Re: March 18 Public Hearing to Appeal Approval of the Illegal Construction Project at 2015 Speyer Lane, Unit B

# Administrative Report

J.1., File # PC21-2220

# Notice of Administrative Decision

(N) REAR ELEVATION

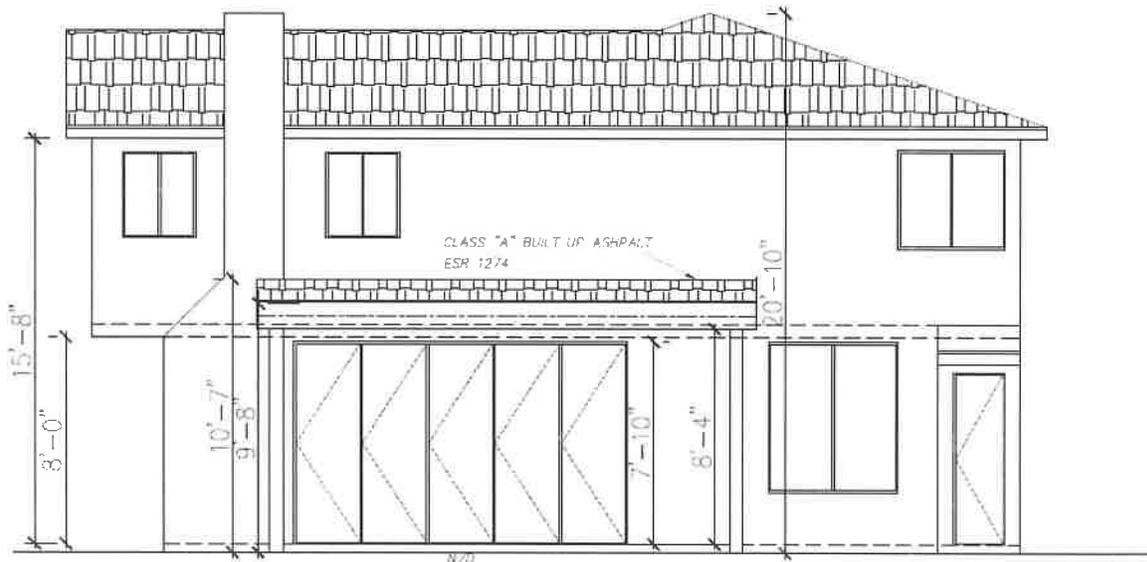
The Zoning Ordinance does not provide a specific definition for “pergola.” When referring to the Merriam-Webster dictionary definition, it states a pergola is “a structure usually consisting of parallel colonnades supporting an open roof of girders and cross rafters.”

Based on the proposed drawings and back-up materials, the structure has a solid roof element, thereby not meeting the intent of a pergola to have an open roof with girders and cross rafters. The back-up materials provided by the applicants as specific examples of other pergola structures in the area show these example structures as each having an open roof with girders and cross rafters. Although the City has no permit records for the previous pergola on this property, the photograph provided shows that this structure was also constructed with an open roof.

Further, RBMC 10-2.1522(a)(2)f.1. states that architectural features approved under this provision cannot exceed 9-feet in height. According to the drawings the proposed structure is 10-feet, 7-inches at the highest point.

Lastly, there is an existing accessory structure approved under a separate building permit, which must also be taken into consideration when reviewing the proposal to add a pergola. As proposed, the roof of the pergola would attach to this existing accessory structure. Per RBMC 10-2.1500, Accessory Structures in Residential Zones, there must be a 5-foot minimum distance between an Accessory Structure and other structures on the lot. Therefore, the approval of the pergola as proposed would create a non-conforming situation where the minimum distance from an existing accessory structure would no longer be met. Additionally, it would in essence “attach” the existing accessory structure to the main home, creating a situation where the rear setback reduces to only 1 ½ feet.

1. Reduce the overall height of the entire structure to 9 feet, as measured from the ground.
2. Redesign the structure from a solid roof to an open roof with girders and cross rafters, to comply with the intent of a pergola structure.
3. Separate girders and cross rafters of the pergola from the existing accessory structure so that the two structures do not touch at any point. Posts supporting the pergola must also remain independent of the existing accessory structure.
4. Set the posts of the pergola in towards the south and to be at least 5-feet away to from the edge of the existing accessory structure to comply with RBMC Section 10-2.1500(a).
5. The ends of the girders and cross rafters comprising the open roof can encroach no more than 30-inches into this 5-foot distance, per RBMC 10-2.1522(a)(1).
